Report to the Sydney Central City Planning Panel

Development application

| DA number | JRPP-16-03306 | Date of lodgement | 31 March 2016 |
| Proposed development | Construction of a part 3 and part 4 storey residential flat building containing 106 apartments, 2 levels of basement car parking, associated landscaping and stormwater drainage works | | |

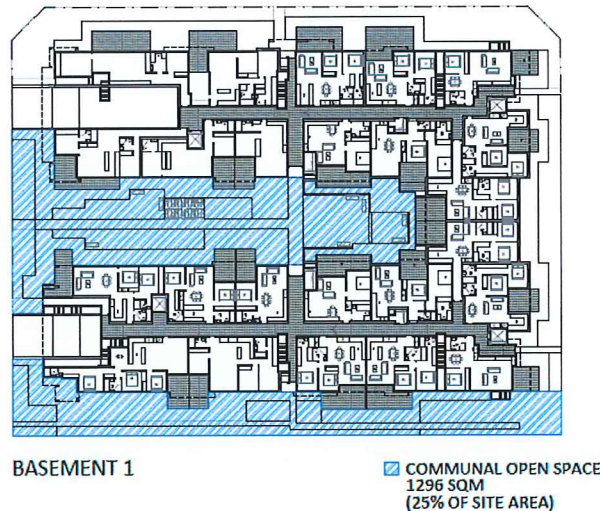
- Location and provision of Communal open space is divided between a centrally located area of 768 m² and an area on the western side of the building of 420 m². An extract of the communal open space location as submitted by the applicant as part of the ADG assessment report is provided below. The applicant indicates that the blue shaded areas form part of the communal open space, achieving 25% compliance. However, the useability is questionable given the location of some areas along the street frontage,

adjoining the basement car parking access and in the case of the western COS, it is located at the back of the building away from many of the apartments within the side setback.

- This issue was raised with the applicant as it was considered to be poorly located and undersized if correctly marked on the plan in relation to the central open space which adjoins the street. In relation to the western open space it appears to meet a landscaping and setback function, rather than a well-designed and useable communal open space as intended by the ADG. The amount of useable communal open space is more like 955 m² (18.3%) if the portions of the COS forward of the building line to Grange Avenue and proposed road no. 2 are excluded from the calculation. The provision of roof top communal open space was considered as part of the assessment but there was no logical point of access to the rooftop without a complete redesign of the floorplan at Levels 3 and 4 to facilitate access. In addition, roof top open space would also require lift overruns which would increase the building height above 14 m, beyond the maximum building height permitted.

- In accepting the location and general provision of communal open space it is acknowledged however that the current landscape design does not achieve the objectives of Part 3D 'Communal Open Space' of the Apartment Design Guide for the full 25%, and that revised plans are required to ensure that a high quality space is delivered.

- Accordingly, to make the remainder of the COS areas more usable, a deferred commencement condition is recommended to resolve the following issues:

- Reconsideration of pathway locations, a reduction in the amount of pathways transecting the 2 spaces could increase the useable areas, especially along the open space to the western boundary

- Size of private terraces at Level 1 and their relationship to the communal open space to be better resolved
- Provide sections showing the relationship between the private balconies/terraces and the proposed communal open spaces

- Provide landscape detail and sections along the street frontages and all planting within the COS areas
- Provide details of the location of BBQ areas and seating and any other improvements to be delivered within the Communal open space for occupant's use

- There is no detail provided as to whether shading is to be provided over any of the deck areas
- Reduction in the amount of decked area is to be reduced and provision of detail as to how this space relates to the private terraces immediately adjoining them

- Ensuring that the architectural plans are consistent with the landscape plans in relation to the size and location of private terraces/balconies as they currently conflict

- Resolution of the western open space is to make it more inviting, with seating options and useable space for residents.
